MONTEREY-MINER (JEMCOR) APARTMENTS PROJECT
RESPONSES TO NON-ENVIRONMENTAL COMMENTS

This Response to Comments document contains comments received during the public review period for the Monterey-Miner (JEMCOR) Apartments Project (proposed project) Initial Study/Mitigated Negative Declaration (IS/MND). The City of Morgan Hill, as lead agency, released the IS/MND for public review beginning on August 6, 2021 and ending on September 6, 2021 pursuant to CEQA Guidelines Section 15105.

Response to Sullivan Letter

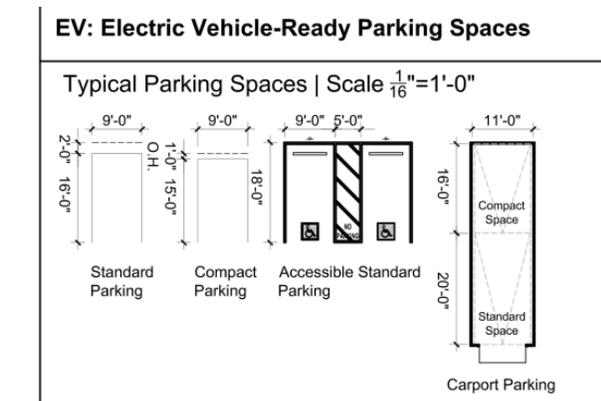
67. Inadequate interface analysis was given to adjacent SFD properties. While there is a step back of heights proposed along Taylor Avenue there is none proposed for the SFD properties on Ginger Way in Buildings 7, 9, 10 and 11 in site plan.

Planning Response: See response to No. 9.
